**GULF STATES UTILITIES COMPANY**

River Bend Station Unit 1  
Docket No. 50-458

Enclosed for your review are Gulf States Utilities Company (GSU) responses to Request for Additional Information identified by the Nuclear Regulatory Commission's Power Systems Branch (PSB). This letter supplements information contained in docketed correspondence from J. E. Booker to H. R. Denton dated December 30, 1983 and February 10, 1984. Attachment 1 of this letter summarizes the Staff request identified in meeting between GSU and PSB dated February 15, 1984. The following enclosures contain the actual written changes to the FSAR text including all tables and figures. These changes will be incorporated into the FSAR in a future amendment.

## ATTACHMENT 1

Fig. 9.5-12  
Standby Diesel Generator

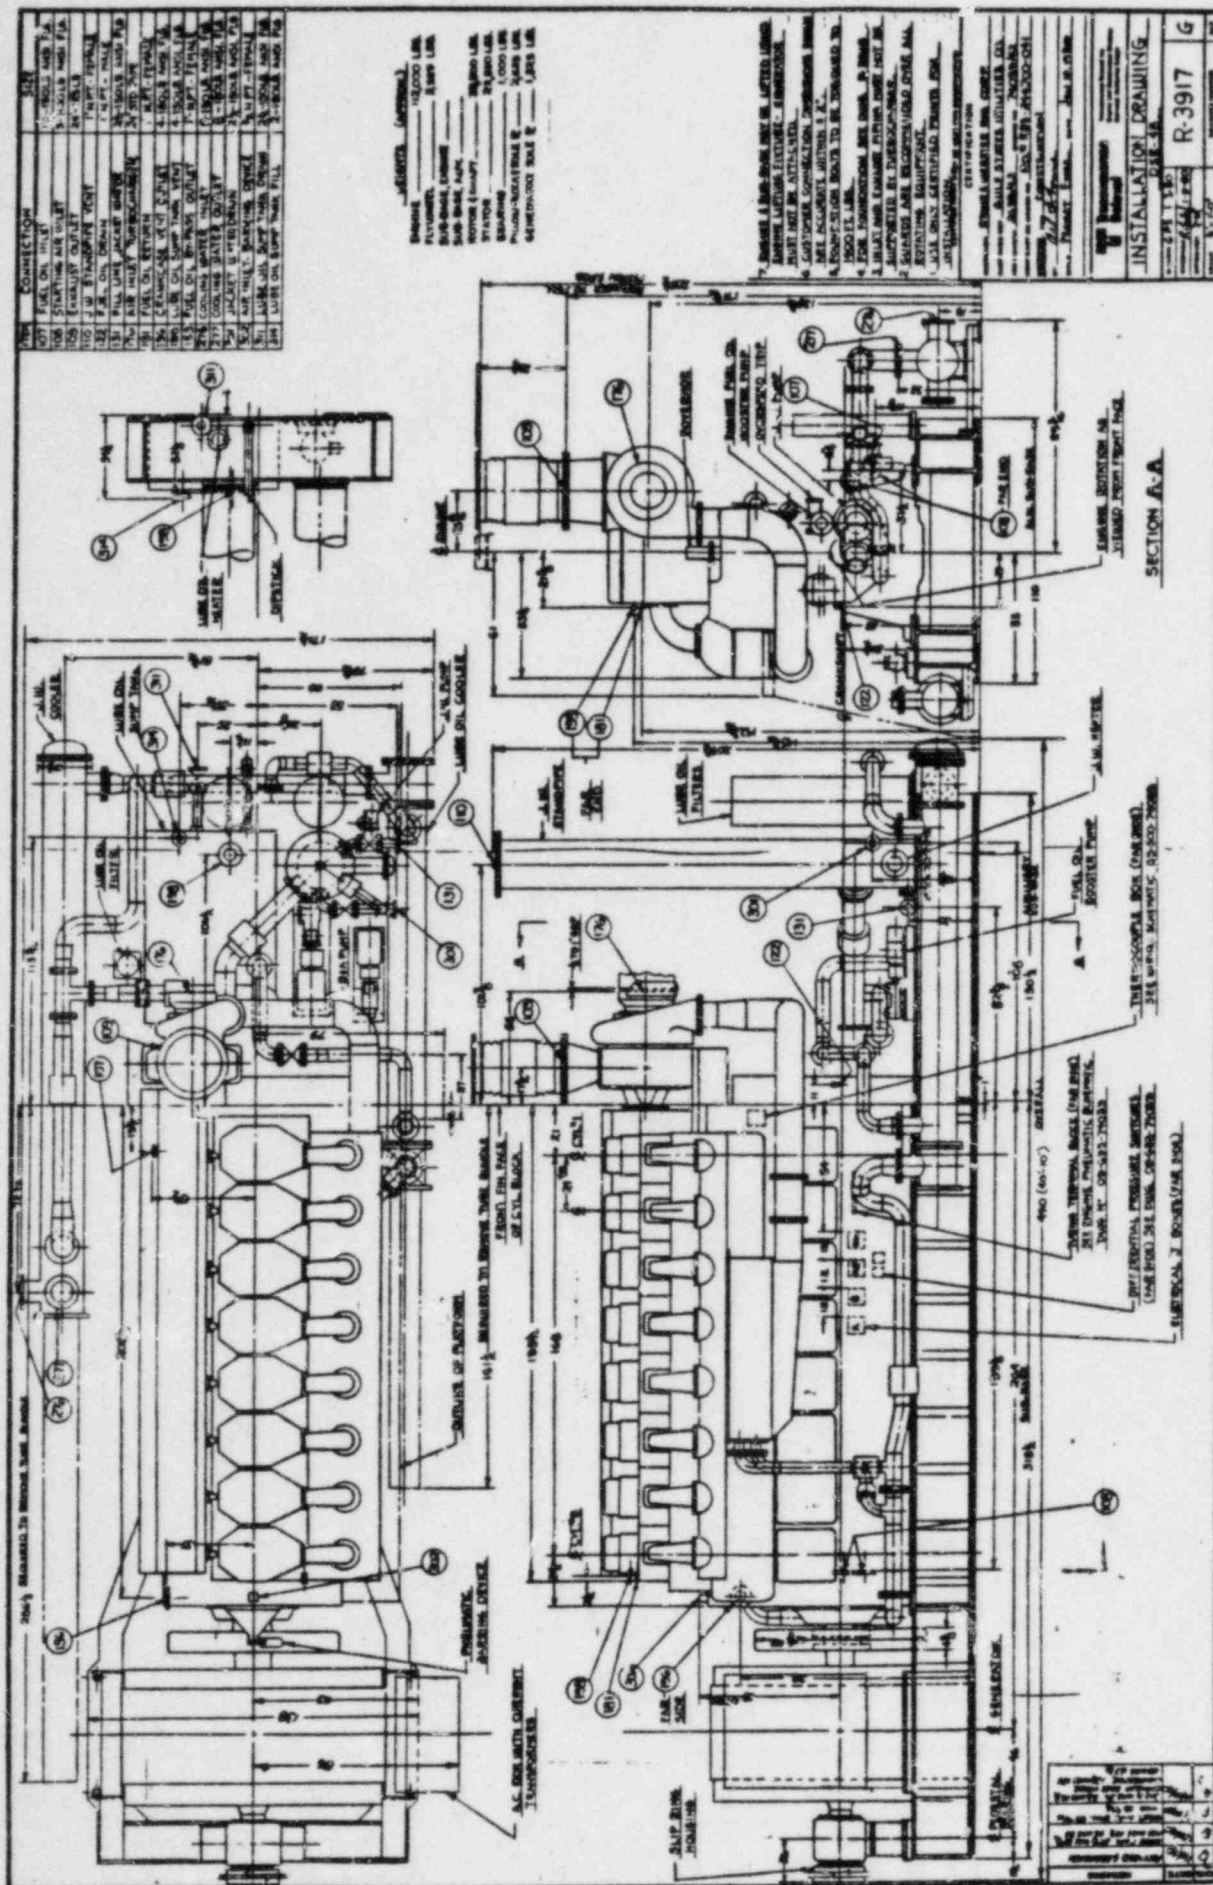
Section 9.5.5 indicates that the function of the diesel generator cooling water system is to dissipate the heat transferred through the (1) engine water jacket, (2) lube oil cooler, (3) turbocharger after-coolers, and (4) governor lube oil cooler. Provide information on the individual component heat removal rates (btu/hr), flow (lbs/hr) and temperature differential (°F) and the total heat removal rate required. Also provide the design margin (excess heat removal capacity) included in the design of major components and subsystems. (SRP 9.5.5, Part III, Item 1).

Component data for the standby DGCWS is shown in Table 9.5-6. The standby DGCWS is a completely self-contained loop, with a vertical standpipe located as shown in Figure 9.5-12. The standpipe is not a pressure vessel; it is an atmospheric vessel, vented to atmosphere. The standpipe provides the flooded suction for the jacket water pumps, acts as a system vent point for de-aeration of the jacket water, provides the point for jacket water system heating and control, and is the system fill and drain point.
